Applicant : Gregory D. Aviza et al.  
Serial No. : 10/774,848  
Filed : February 9, 2004  
Page : 10 of 15

Amendments to the Drawings:

Applicant(s): Gregory D. Aviza et al.  
SHAVING RAZORS, AND BLADE SUBASSEMBLIES  
THEREFOR AND METHODS OF MANUFACTURE  
MPEB# NO. 00216-621001

New claim 27

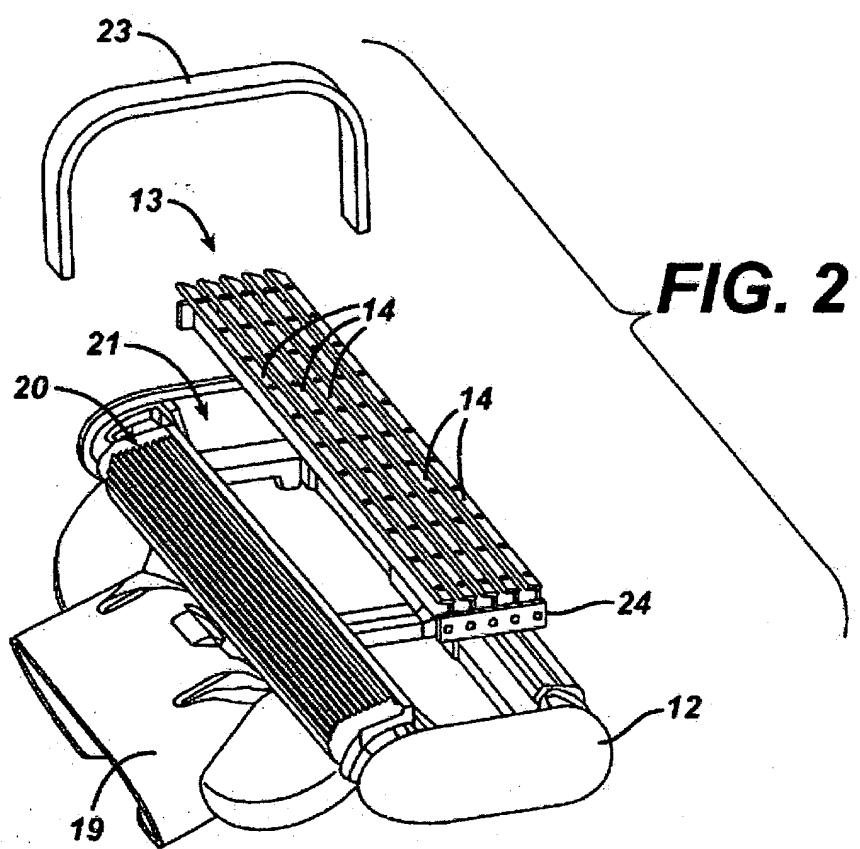
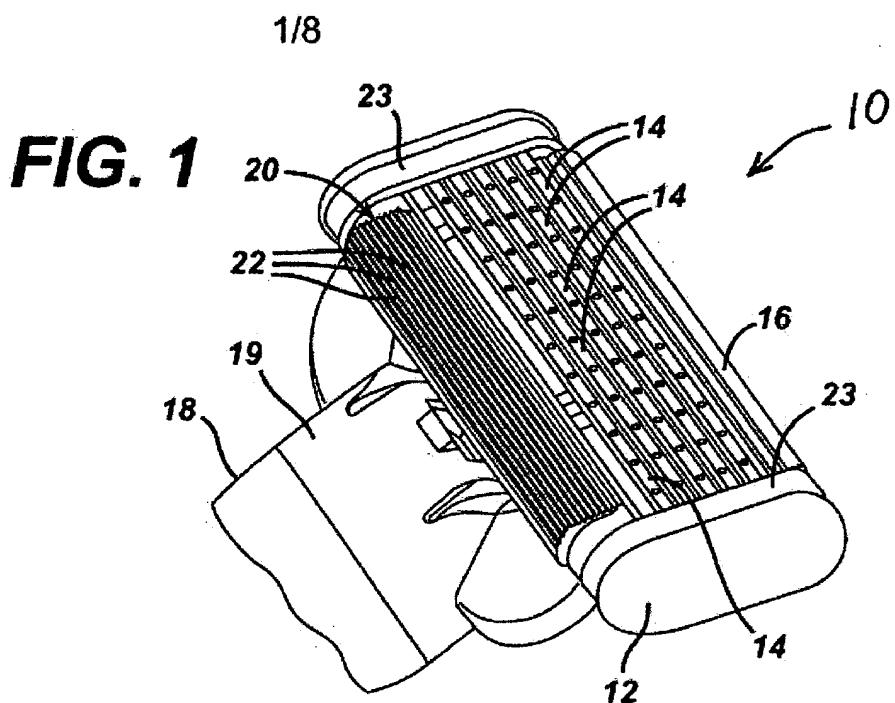
New claim 27 includes original claim 16 and the features that the opposed longitudinal ends extend transverse to the cutting edge in a direction from the edge extending rearward, as shown in Figures 7, 12 or 13. This provides the suitable lands at which the weld connections are made in a lateral plane away from the plane of the cutting edges, as shown e.g. in Figures 8 or 10, to provide stability to the overall assembly as well as desirable conformance of the blades to the surface being shaved, which is not shown or suggested in the references of record including not in Gooding.

**FIG. 9**

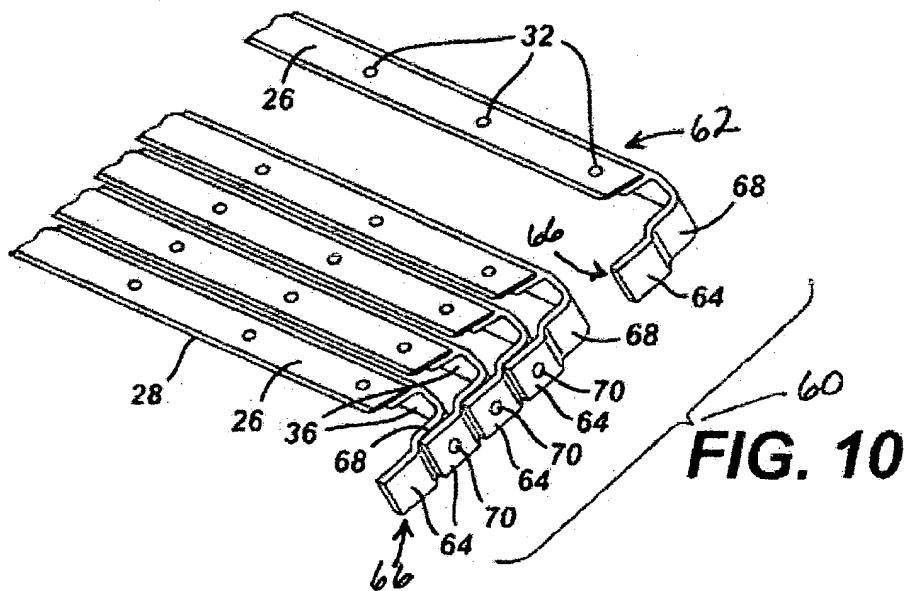
Reference numeral "46" had been inadvertently used twice. In Figure 9, reference numeral "46" is changed to "47".

**FIG. 10**

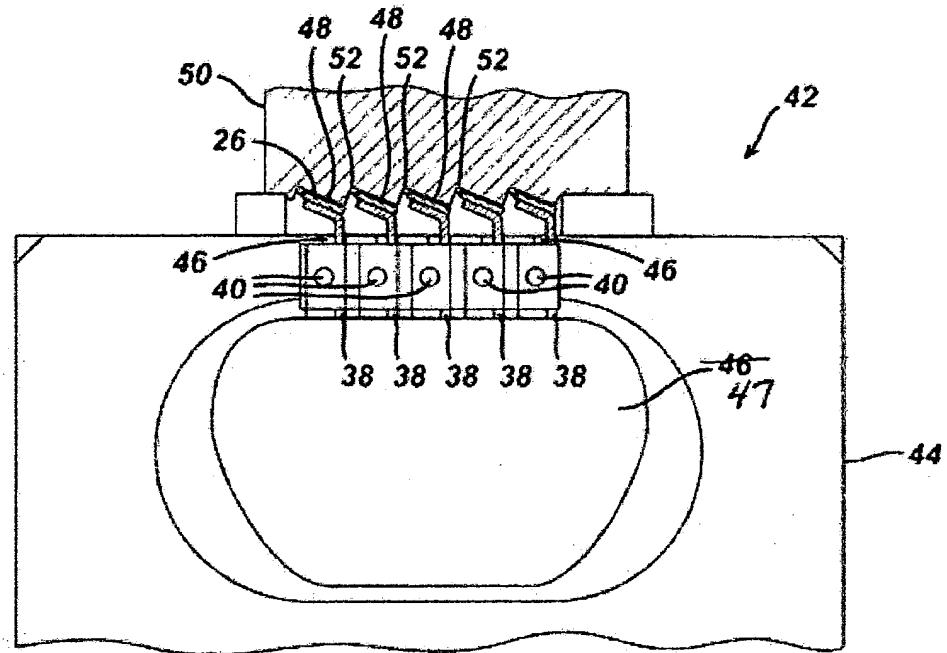
The attached replacement or sheets of drawings (1/8 and 5/8) includes changes to Figures 1, 9 and 10 and replace the original sheet containing those figures.
